File #: SUB 19-02 – Tofte Farms No. 6

HEARING DATE: December 9, 2019
STAFF REPORT DATE: November 27, 2019
TO: Planning Commission
STAFF: Sandy Freund, AICP, Senior Planner

The applicant requests approval to subdivide a ±4.06-acre parcel into 16 single-family residential tax lots with associated public infrastructure. This is the final phase of the Tofte Farms Subdivision Master Plan.

SITE PLAN

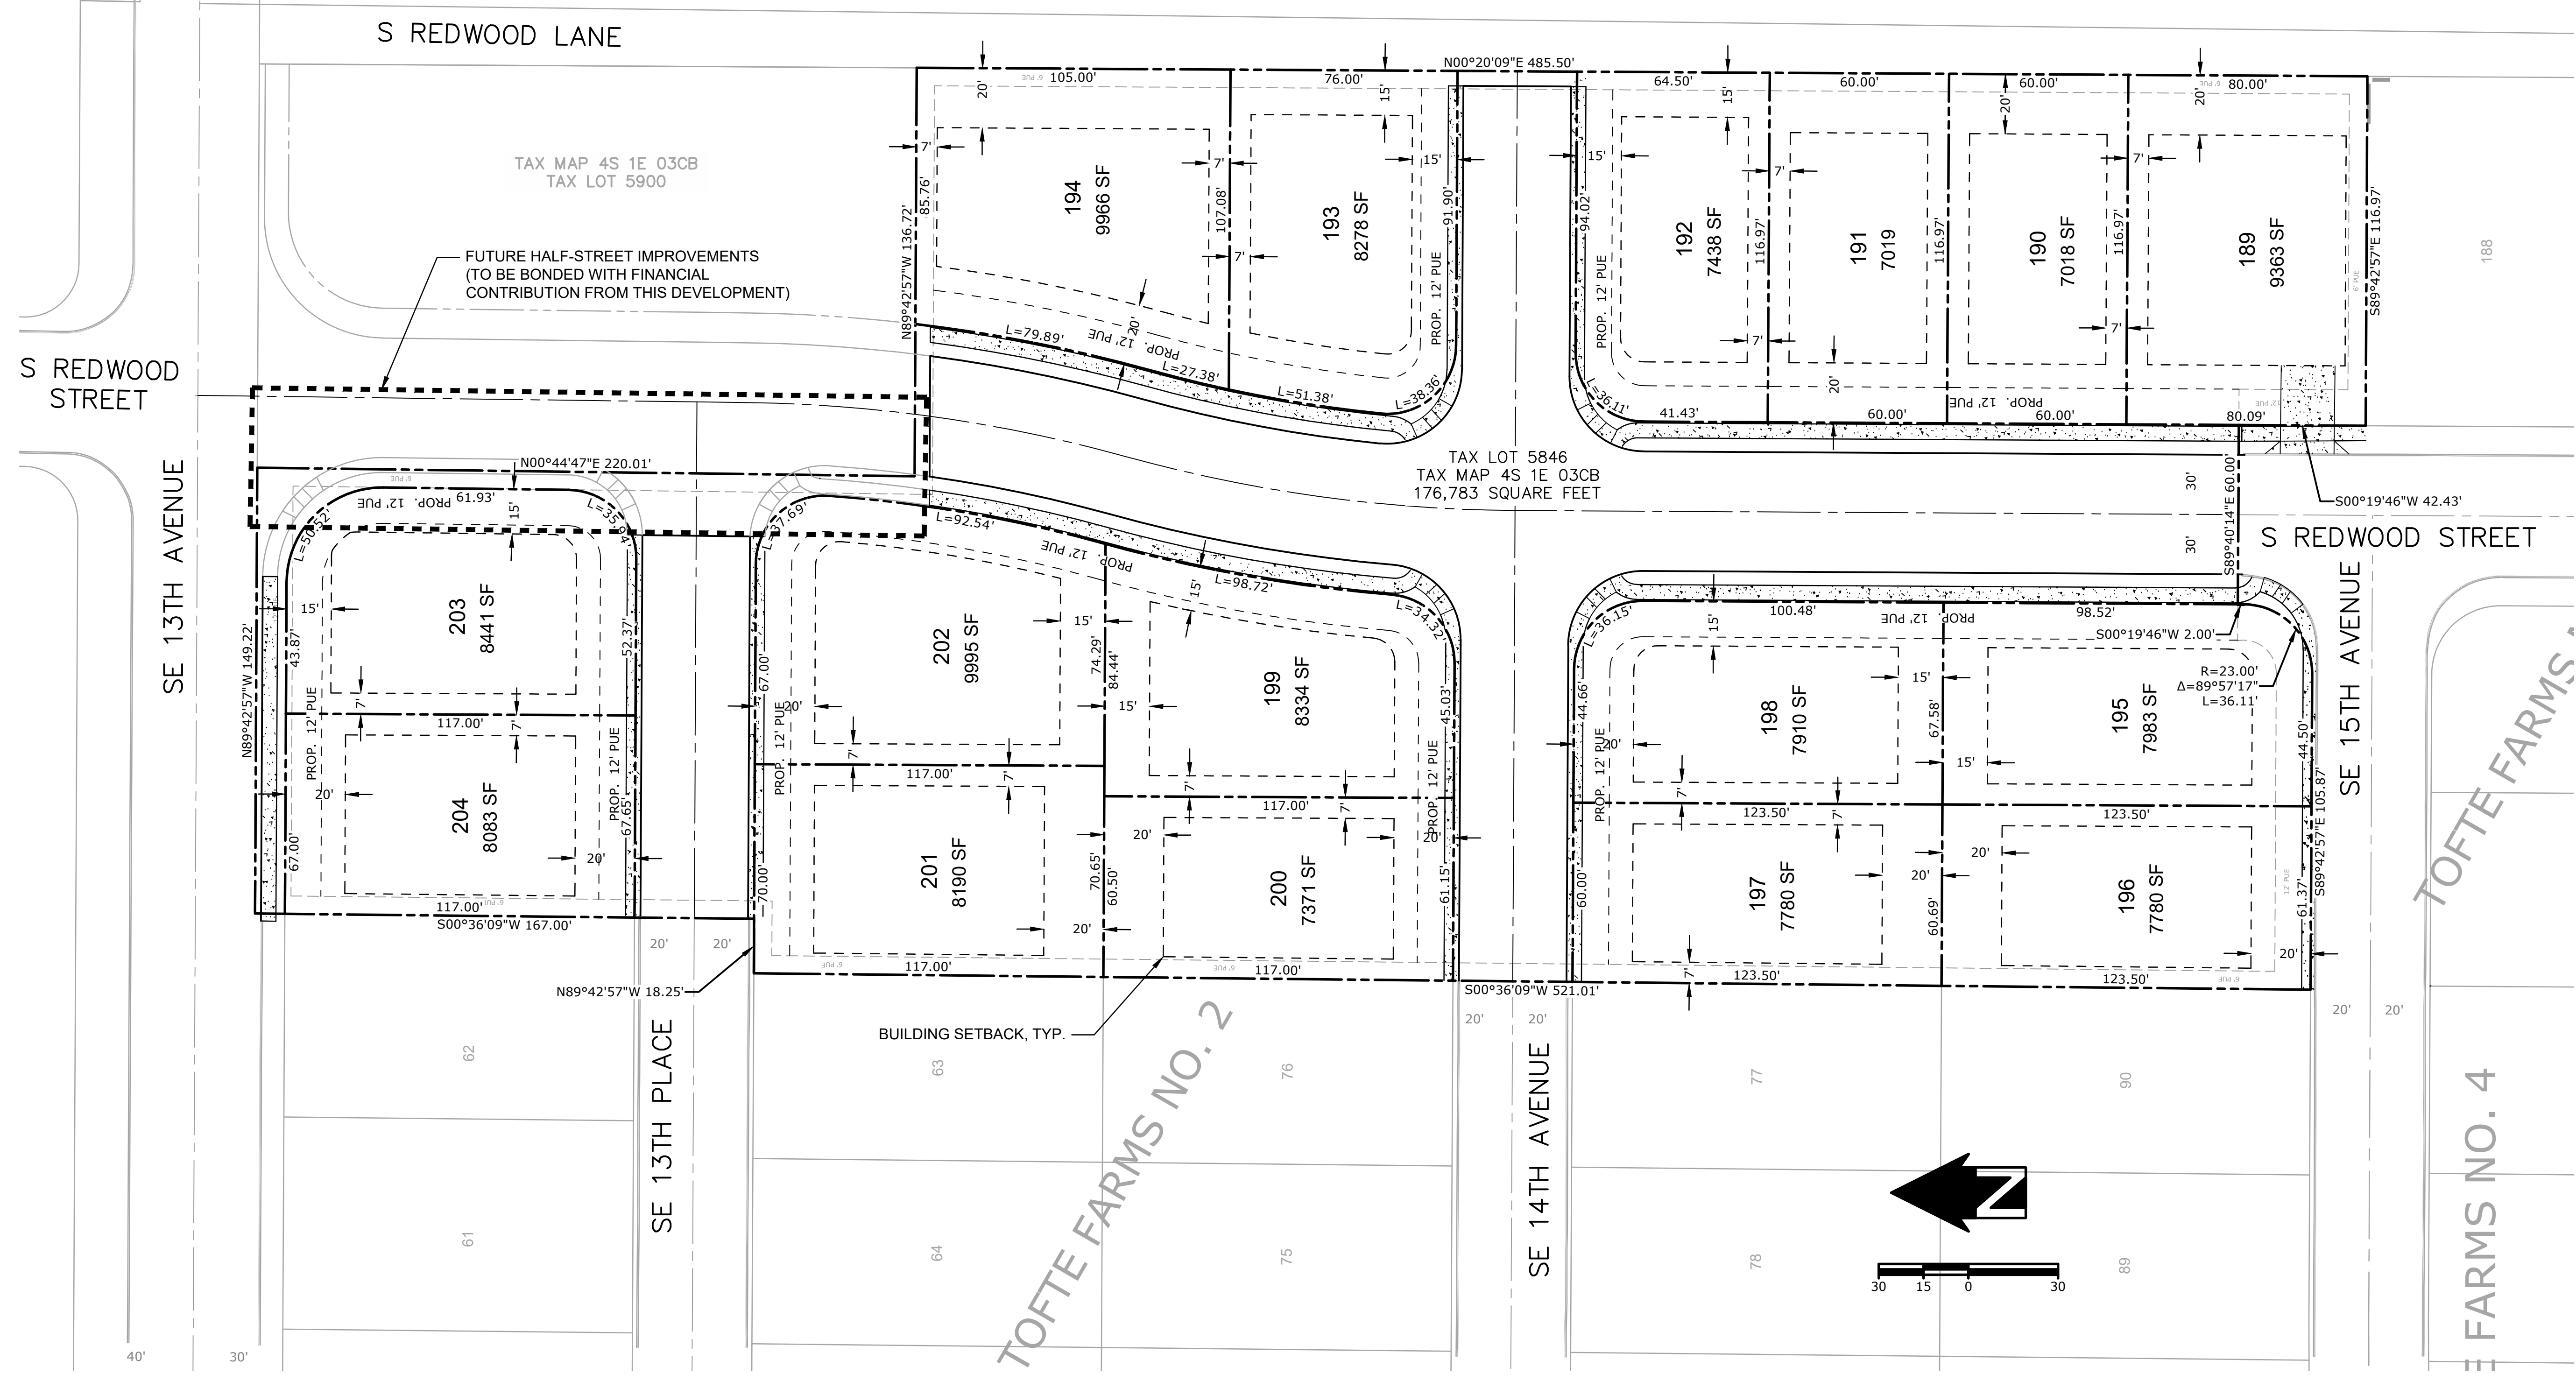
The subject site will be accessed from existing local streets which have been stubbed in anticipation of future extensions to the project site. Per Sheet 3 of the submitted plan set, the applicant has provided three access points to the 16-lot subdivision, thereby complying with Section 16.46 Access of the *Ordinance* which requires a minimum of one access point for up to 30 residential lots. The existing streets to be extended to the east from S. Ponderosa Street include: SE 14th Avenue, and SE 13th Place. Both streets will continue with the extension of five-foot wide sidewalks on both sides. S. Redwood Street will be extended to the north to SE 13th Avenue, and include five foot wide sidewalks, and 4.5-foot wide planter strips.

8. All interior streets within the subdivision, S. Redwood Street, SE 13th Place, and SE 14th Avenue, shall be designed to City local street standards matching the existing street paved width, curbs, 4.5-foot wide planter with street trees (S. Redwood Street only), 5-foot wide concrete sidewalks to match existing, street lights and utilities in conformance with Chapter 2 of the City of Canby Public Works Design Standards, dated June 2012. A 12-foot wide public utility easement (P.U.E.) and S.W.E (sidewalk easement) abutting the right-of-way shall be required for the extended east/west streets. (City Engineer – HB)

UTILITY PLAN

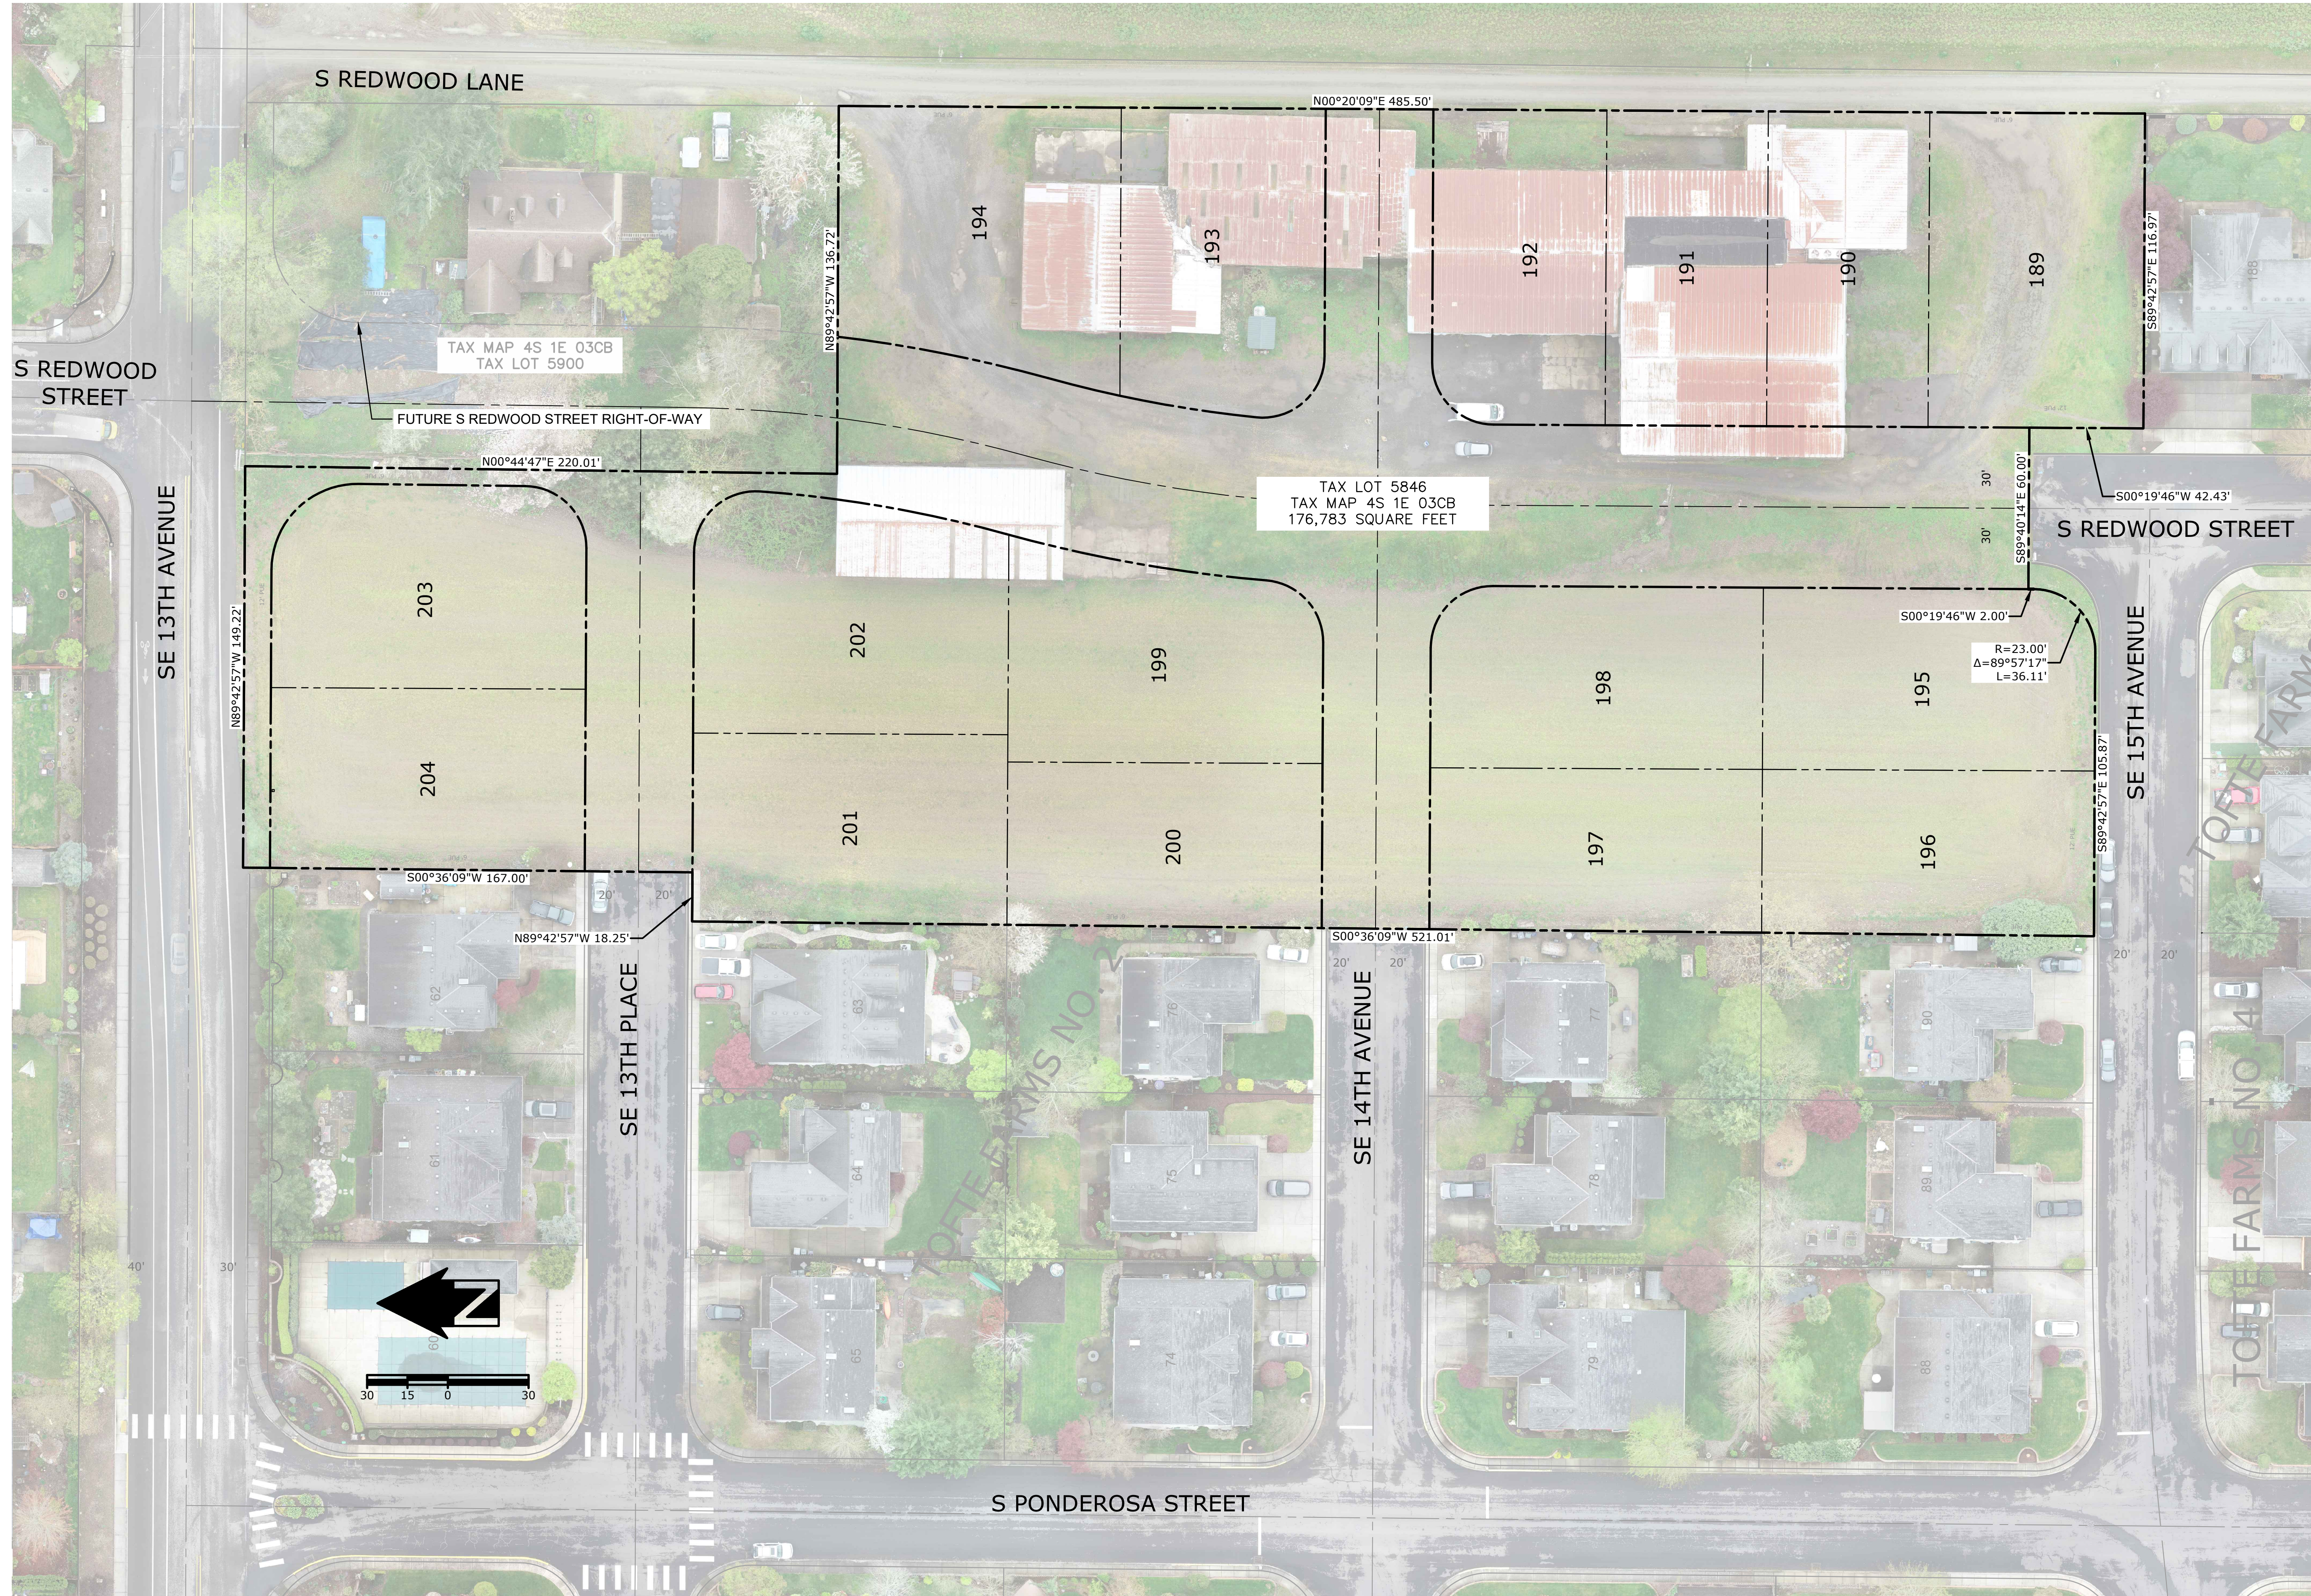
The applicant has stated that all necessary public facilities are available to serve the proposed residential development, as illustrated on Sheet 5, *Utility Plan*, of the submitted plan set. Staff has reviewed the plan set, and has provided conditions of approval requiring that the necessary public facilities be constructed to adequately meet the needs of the proposed land division. Therefore, staff finds, as conditioned, this criterion has been met.
